DEVELOPMENT REVIEW BOARD  
SUPPLEMENTAL SUBMITTAL

PROJECT NO. PR-2019-002277  
Application No. SI-2019-00246

SUBMITTAL DESCRIPTION: DRB Site Plan Resubmittal.

**RE: Adagio Apartments  
PR-2019-002277**

SHEET NUMBER: C-100

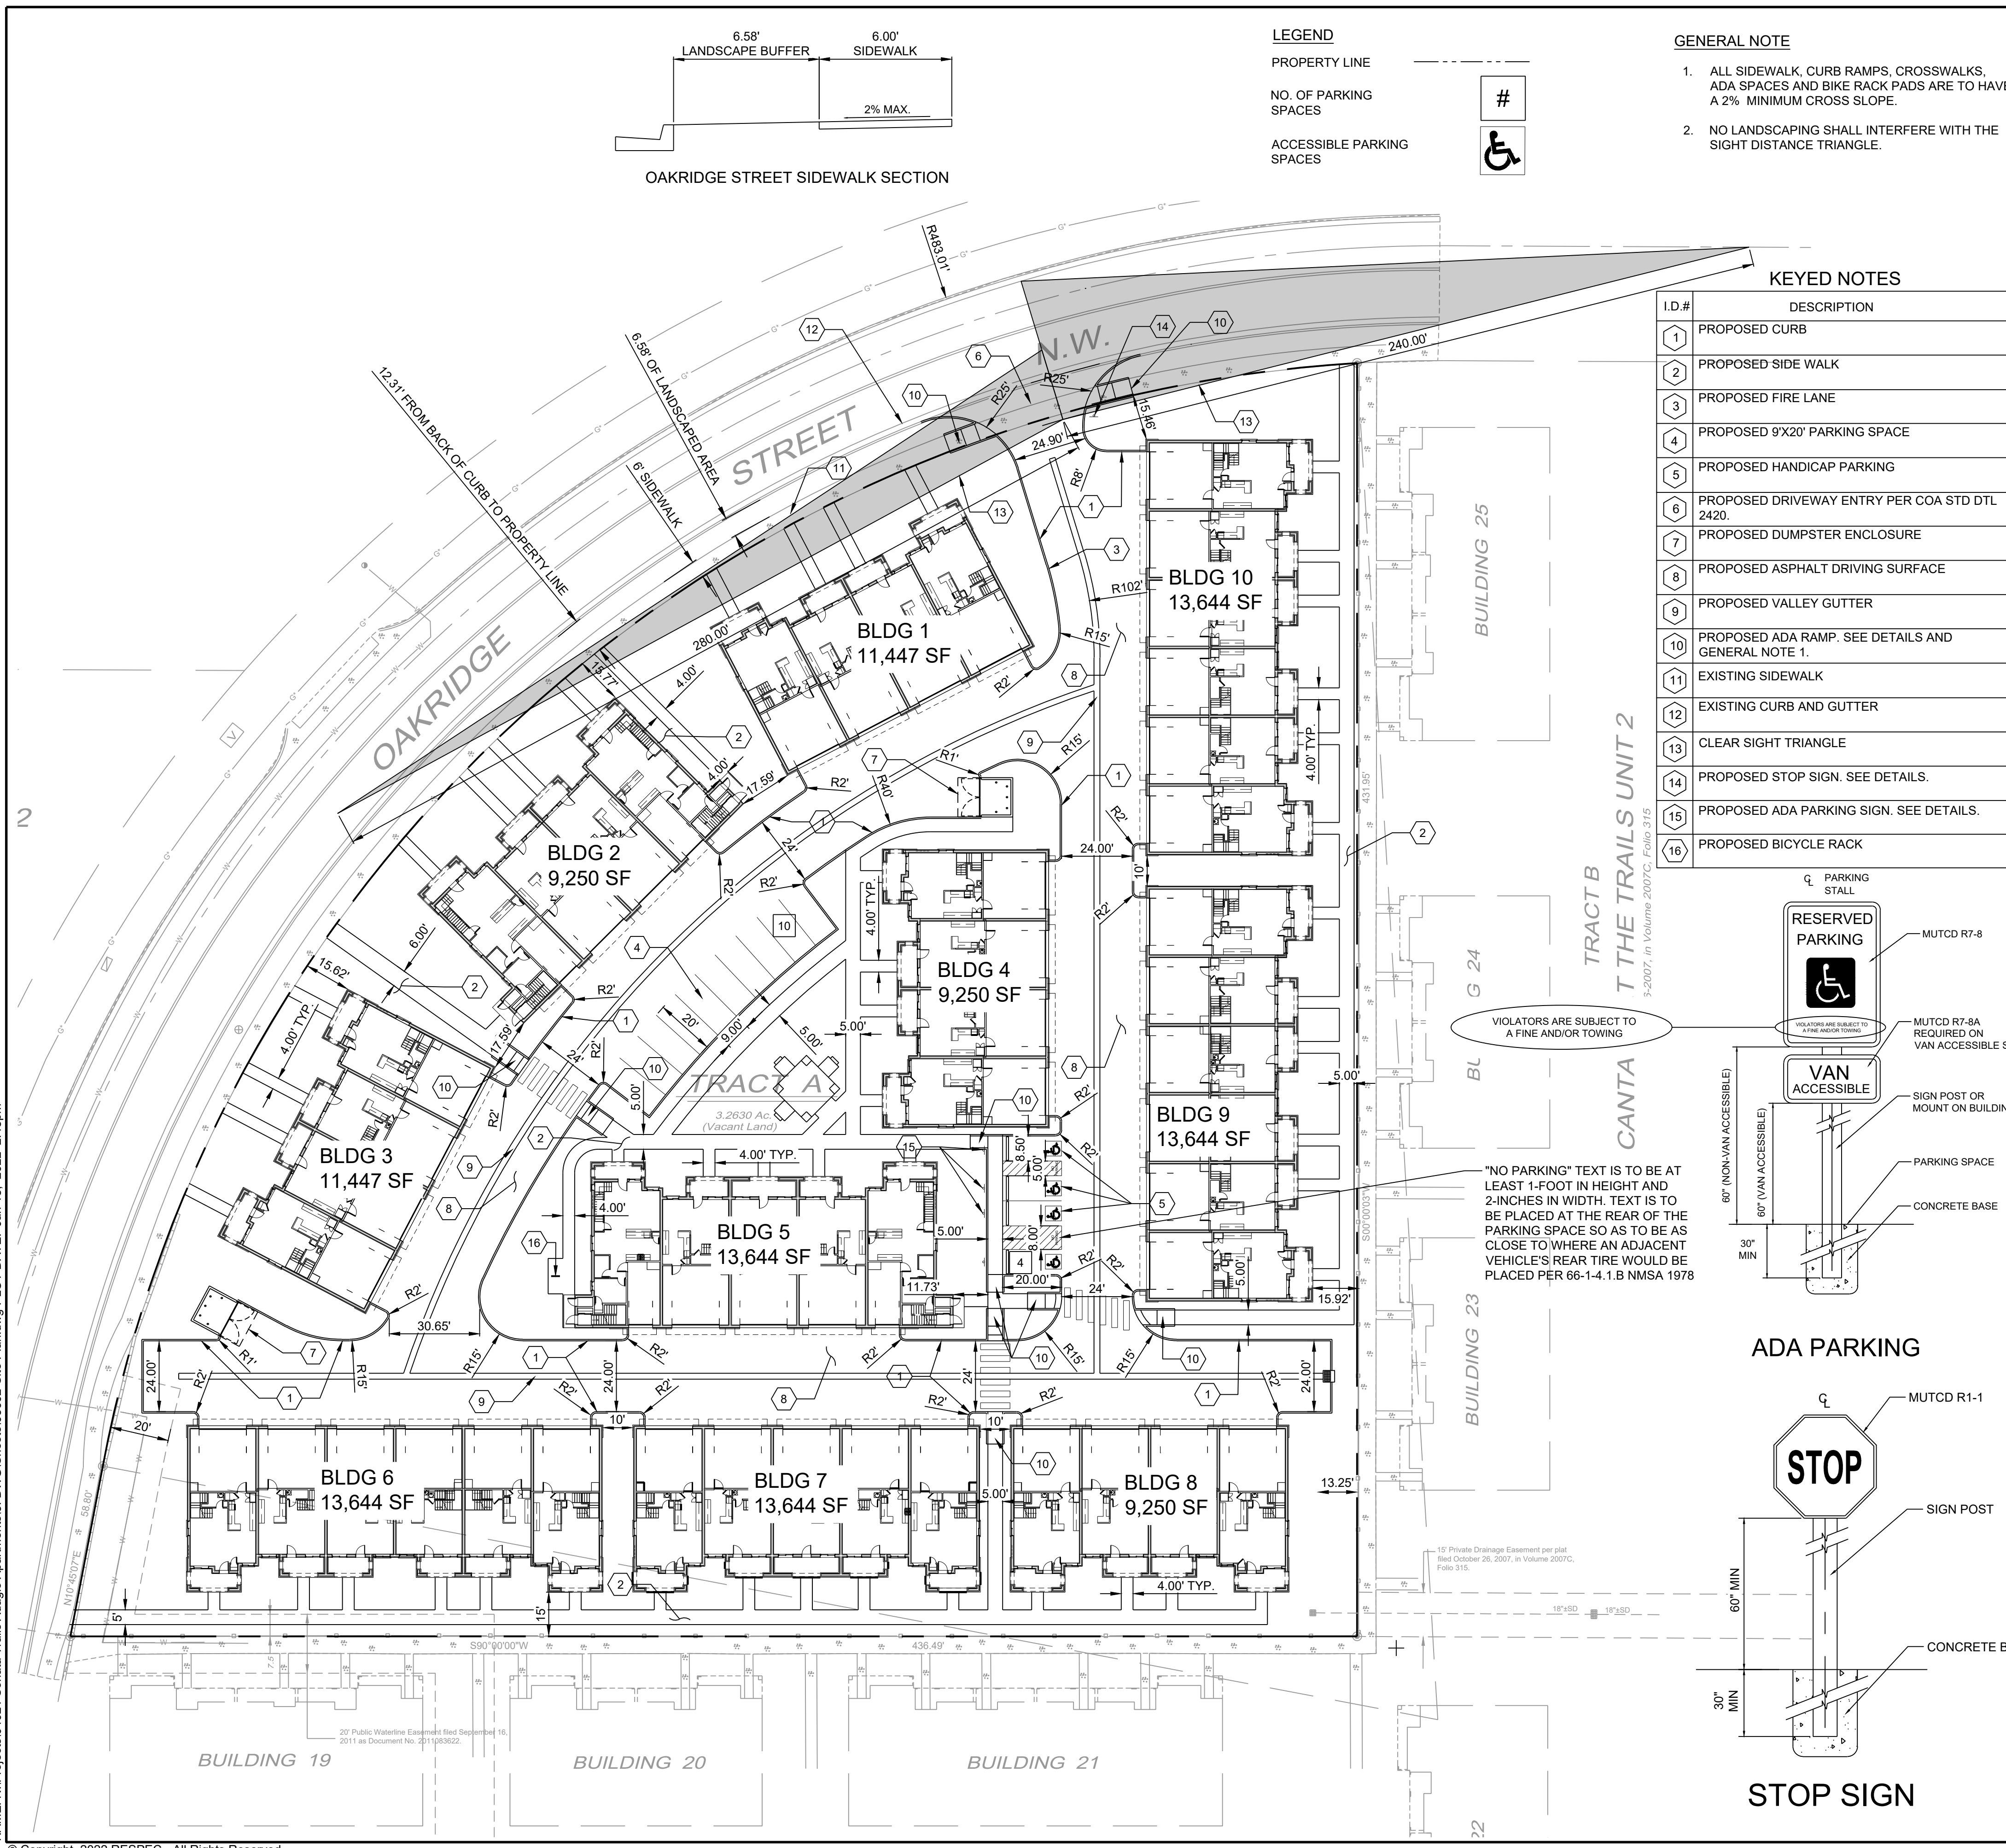
- / Between Buildings 7 and 8, provide curb ramp for ADA accessibility or demonstrate ADA accessibility at this location.
  - o *Response: A keyed note has been added to the Site Plan to show the ADA ramp between Buildings 7 and 8.*

- / Provide all driving aisle dimensions along Buildings 6, 7, and 8.
  - o *Response: Drive aisle dimensions are included along Buildings 6, 7, and 8 on the Site Plan.*

- / Label width of all sidewalks on the plan. (Note this for sidewalk to individual apartments. Typical note can be used.)
  - o *Response: Sidewalk widths are labeled on the Site Plan.*

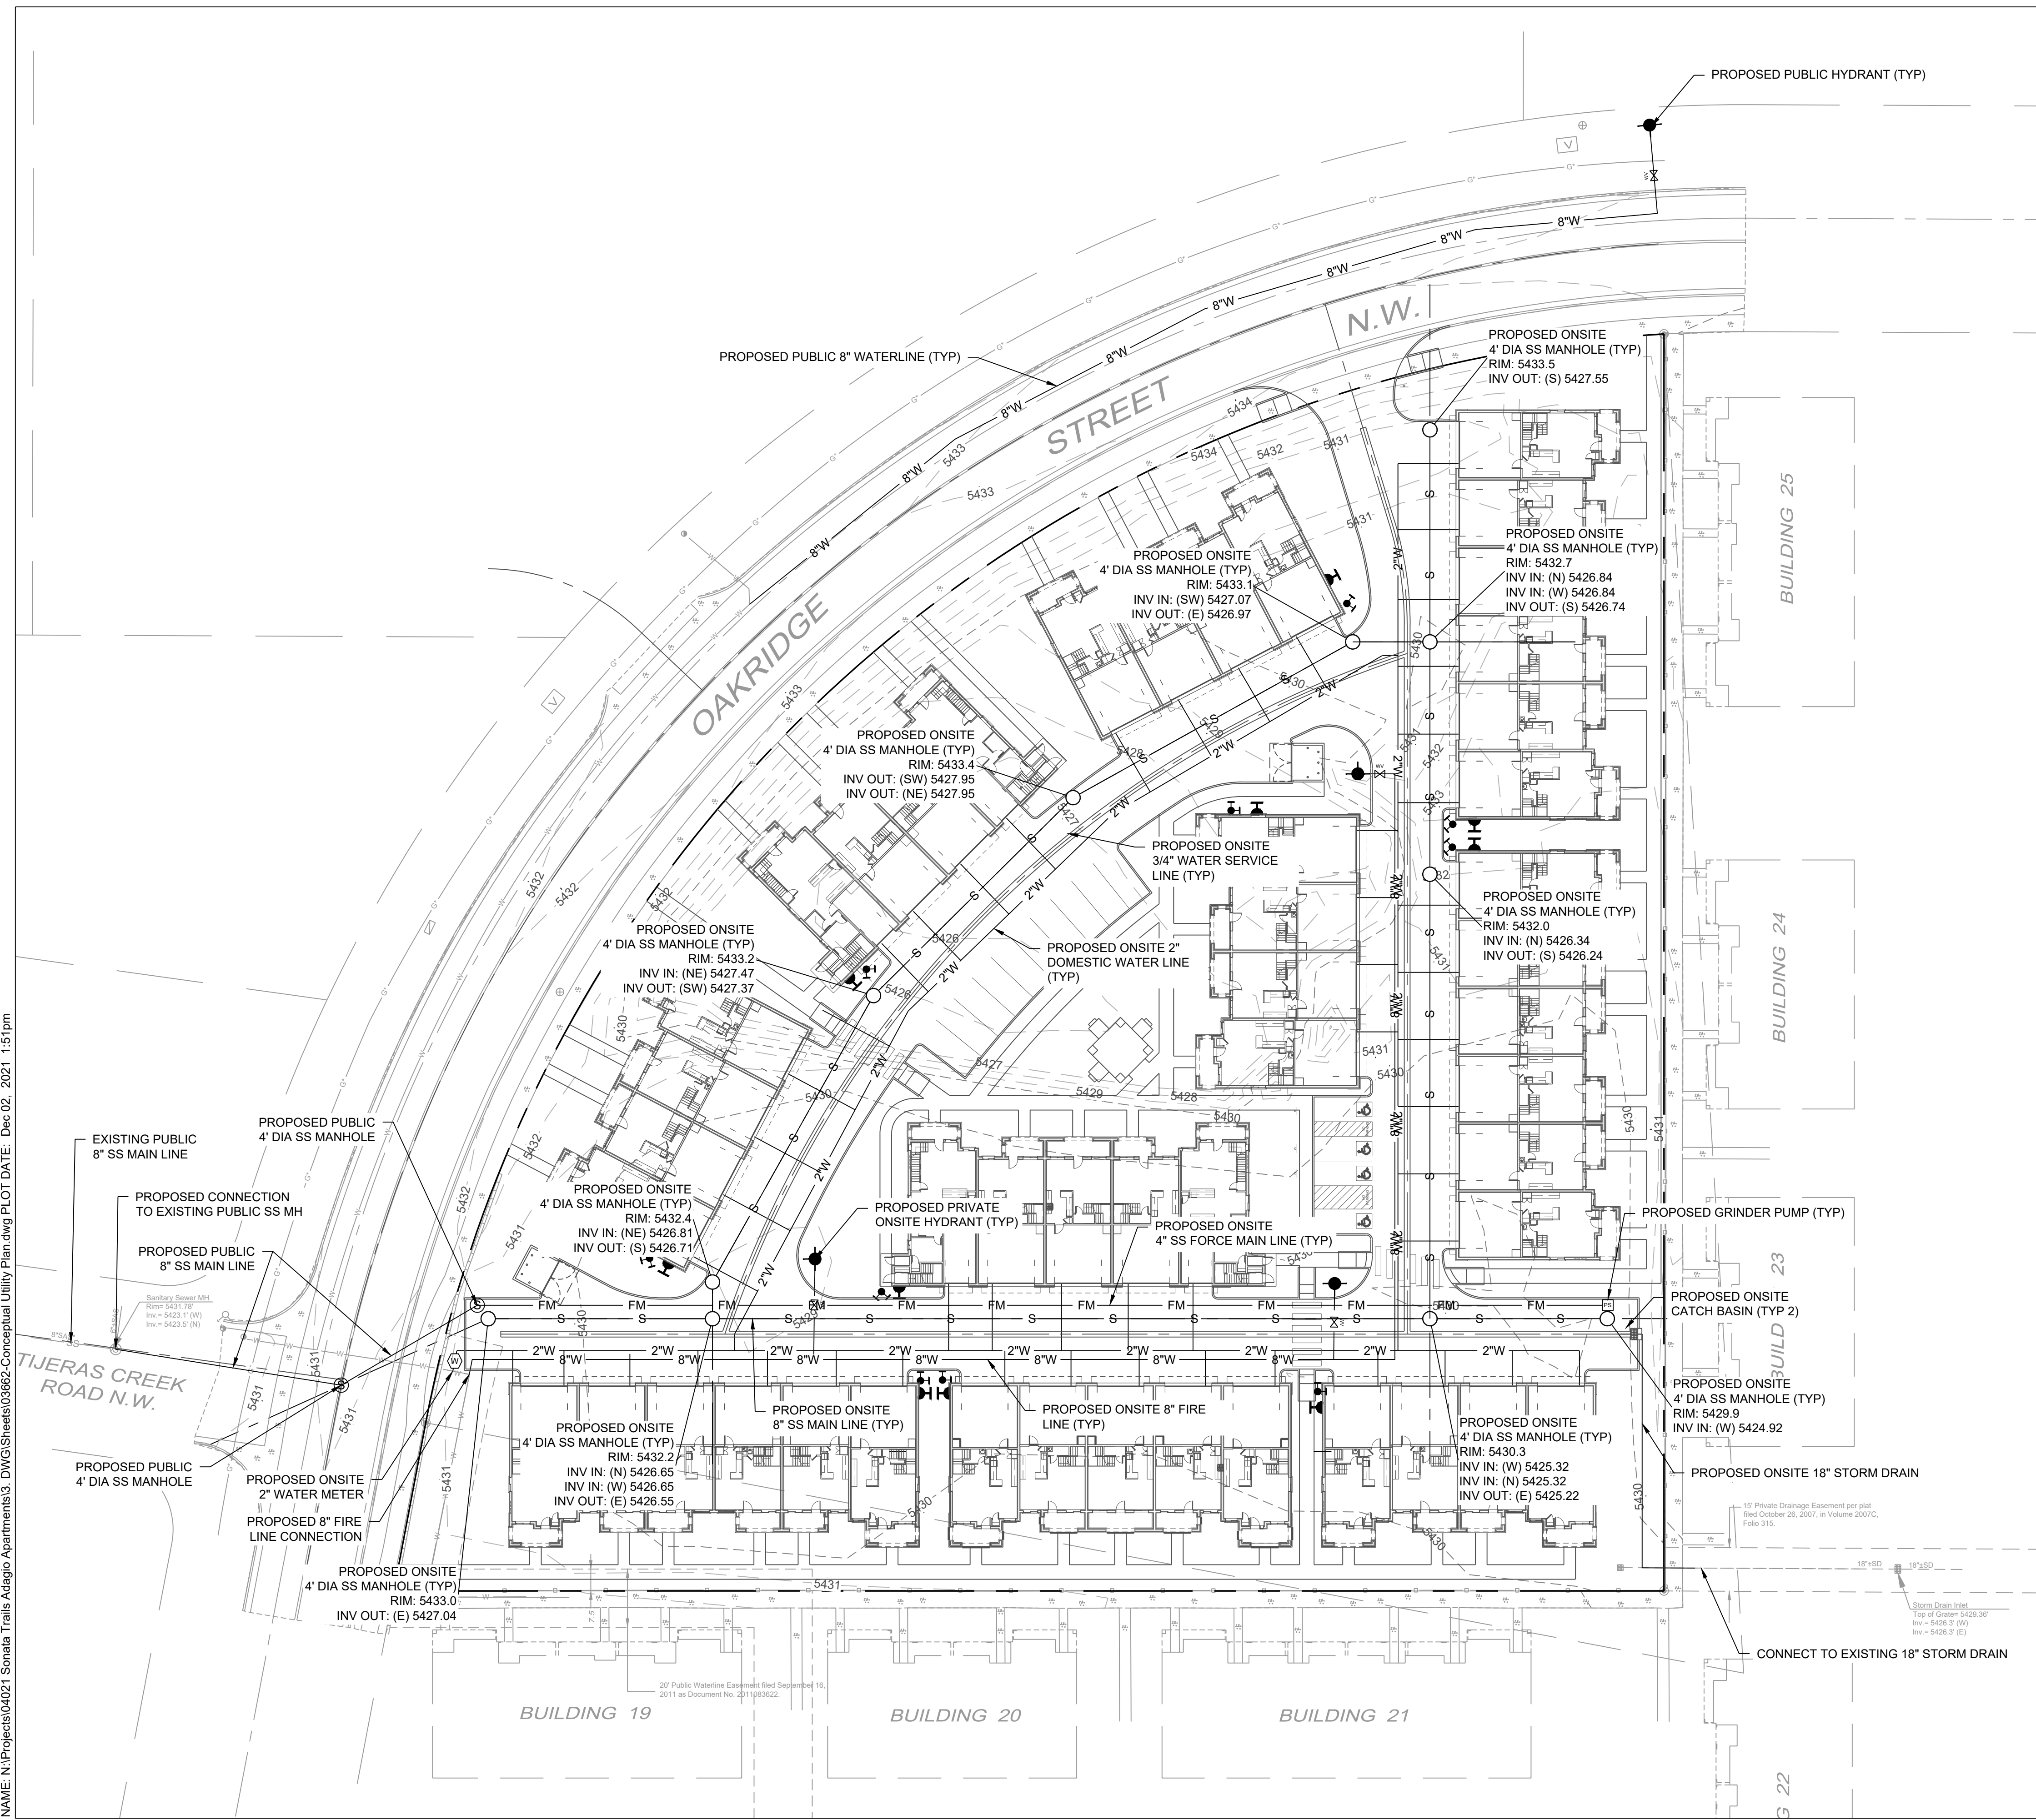
- / Utility Plan
  - The lack of a sewerline in Oakridge requires the update to the serviceability letter and board approval.
    - *Response: Acknowledged.*

PROJECT NAME:	ADAGIO APARTMENTS	
SHEET TITLE:	DETAILS	
SUBMITTED FOR:	DRB DETAILS	
SHEET NUMBER:	C-500

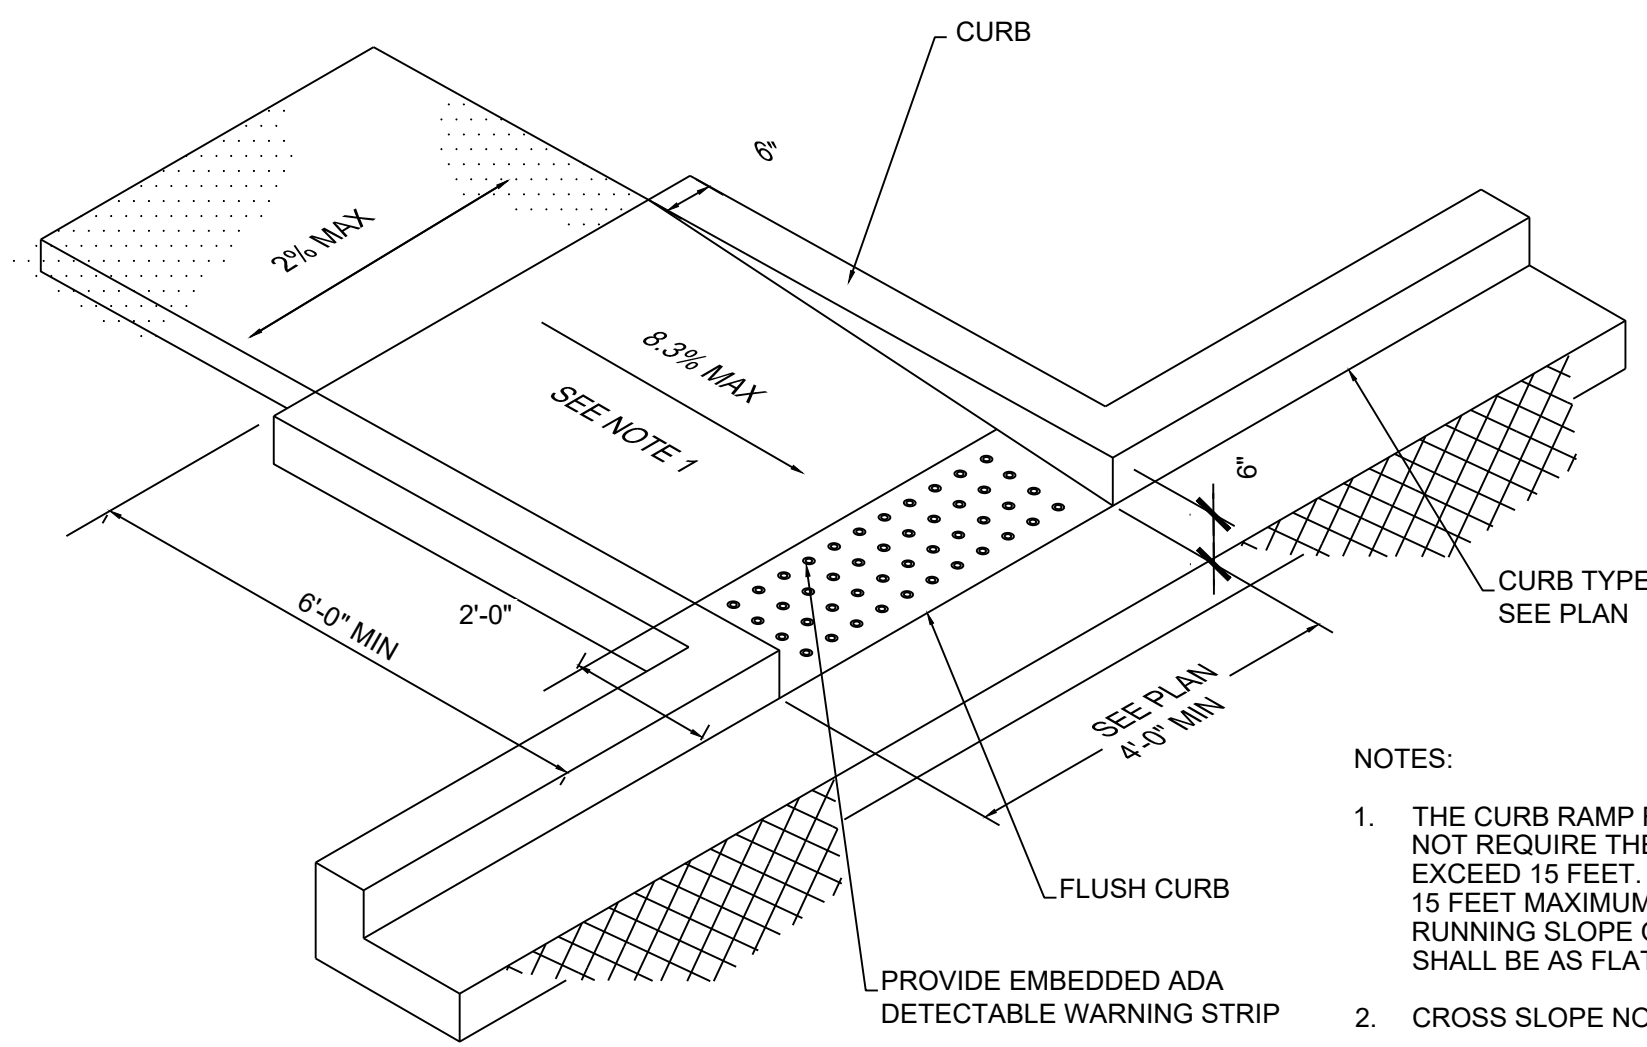
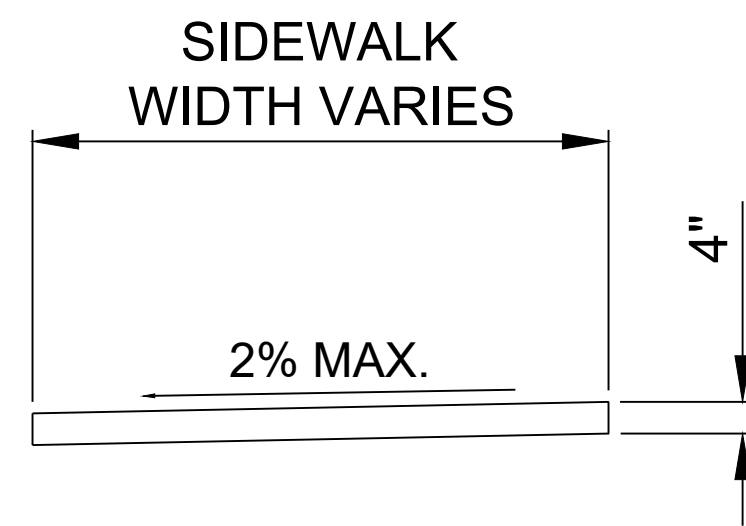
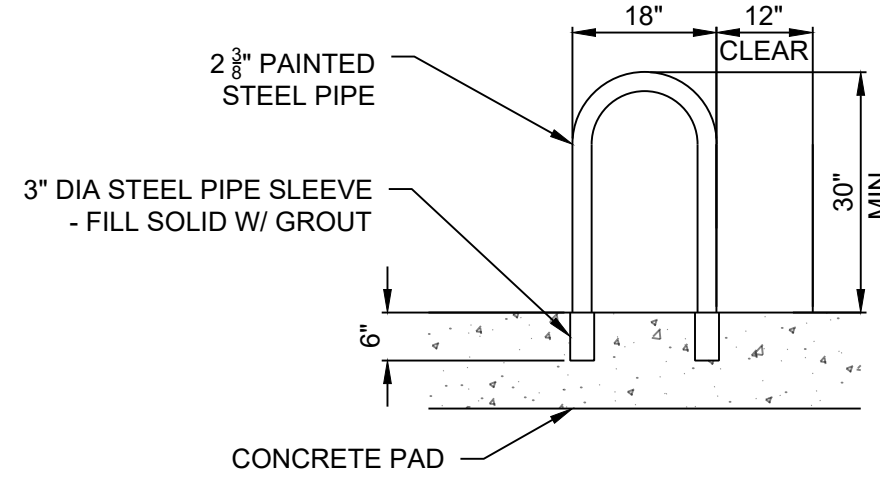
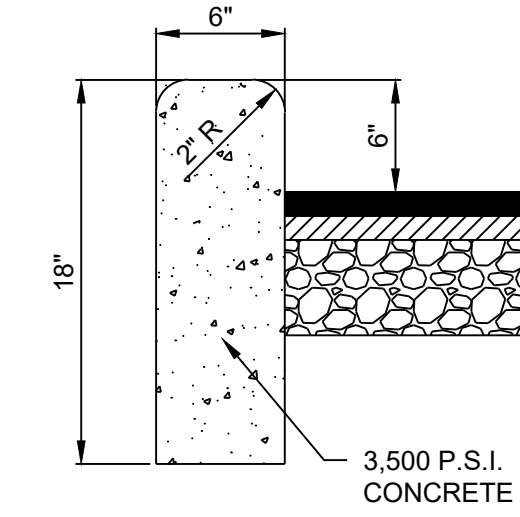
- / Provide more detail at the entrance with regard to ADA accessibility. Provide bike rack detail along with spacing in between bike racks. Provide curb and sidewalk detail showing 2% maximum cross-slope. (Follow IDO/DPM guidelines on needed bike rack details.) (Use correct COA standard detail references for the entrance.)
  - o *Response: A bike rack detail has been included on Detail Sheet C-500 as well as curb and sidewalk details. Driveway entrance on the Site Plan references COA Standard Detail 2420.*
